Subject	Meeting Minutes - Citizen Advisory Group (CAG) Meeting #6
Meeting Date	December 6, 2016
Scheduled Time	6:00 pm – 7:00 pm ET
Location	Port Authority Conference Room, 90 Moonachie Avenue, Teterboro, NJ 07608
Attendees	Attendee list available, <i>for internal use only</i>

REBUILD BY DESIGN MEADOWLANDS

CITIZEN ADVISORY GROUP (CAG) MEETING #6

ALTERNATIVE 1: STRUCTURAL FLOOD REDUCTION CONCEPT DEVELOPMENT

ALIGNMENT OPTION – ZONE 1

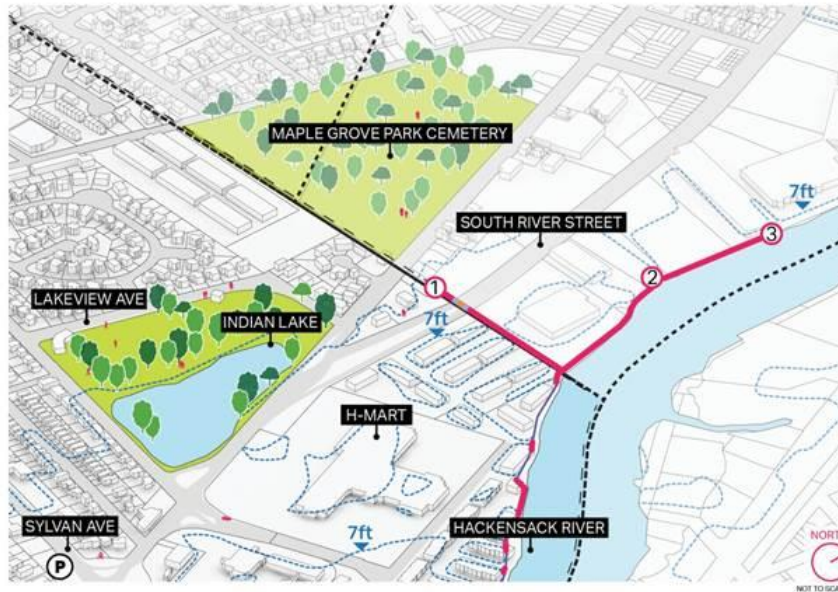
5. In reference to the Zone 1, Option 3 that connects to the Riverwalk, is this area already protected?

7. In reference to Zone 1, are there already berms in the discontinuous areas?

Response: Yes, the Riverwalk is at 7 feet NAVD 88. For example, the homeless shelter and jail to the north are already protected. With Option 1, a road closure would be needed, which is not ideal for evacuation purposes. Although Option 2 is located outside the Project Area, only a small number of modular units would be needed and no road closures would be required. With Option 3, the addition of a few more modular units would allow tie-in to the Riverwalk area.

Response: The 7-foot elevation alignment would result in a discontinuous flood control structure in this area because it would be tied to existing high ground (7 feet NAVD 88). However, for example, an 8-foot NAVD 88 alignment would be continuous in this area.

ALIGNMENT OPTION – ZONE 6

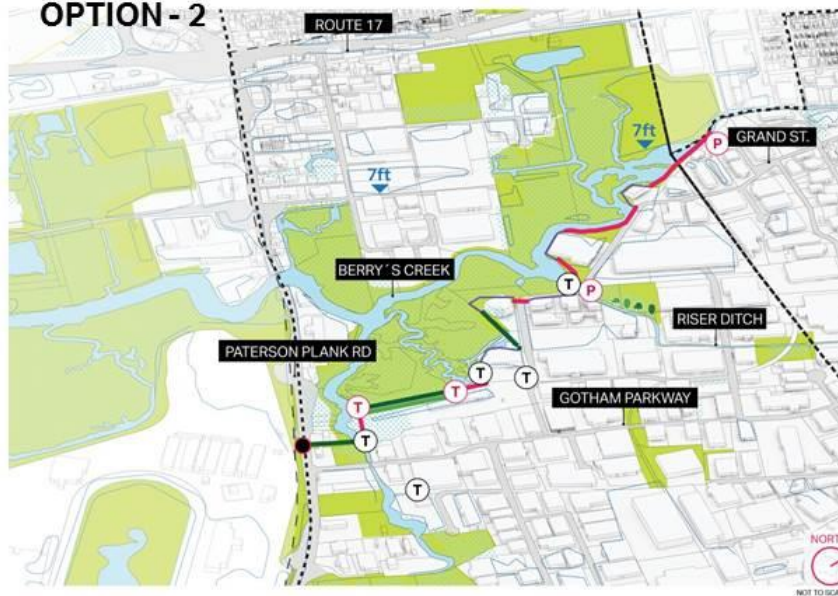
4. How would the surge barrier on Berry's Creek at Paterson Plank Road operate under the Zone 6, Option 1?

Response: This option would protect approximately 50 percent of the Project Area. The surge barrier would only be closed during storm events; it would most likely be operated automatically (not manually). This would reduce the chance for human error; however, should it fail, a large portion of the Project Area would be susceptible to flooding during a large storm event.
